OYSTER CREEK NUCLEAR GENERATING STATION, UNIT NO. 1

AMENDMENT TO PROVISIONAL OPERATING LICENSE

Amendment No. 14
License No. DPR-16

ATTACHMENT TO LICENSE AMENDMENT NO. 14

FIGURE 4.5.1

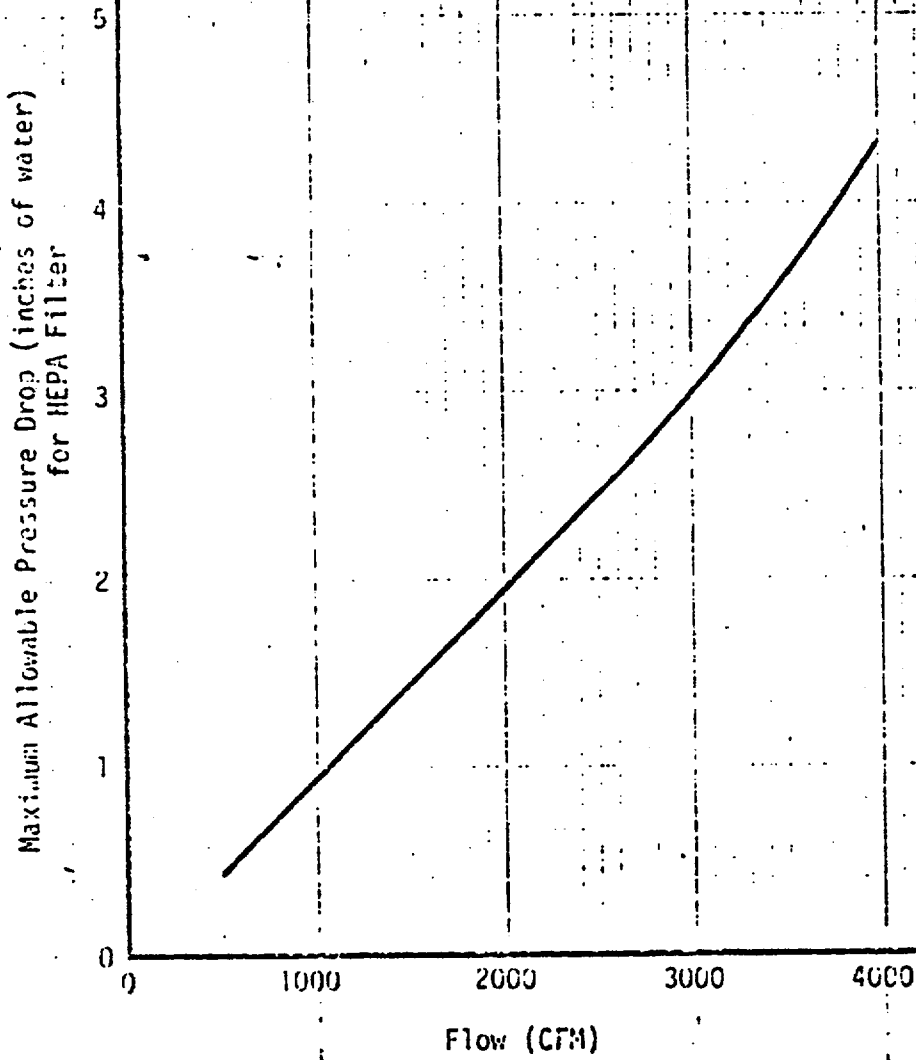
- (3) Air distribution is uniform within $\pm 20\%$ across the HEPA and charcoal filters.
 - b. At least once per 18 months by demonstrating:
 - (1) That the pressure drop across a HEPA filter is equal to or less than the maximum allowable pressure drop indicated in Figure 4.5.1.
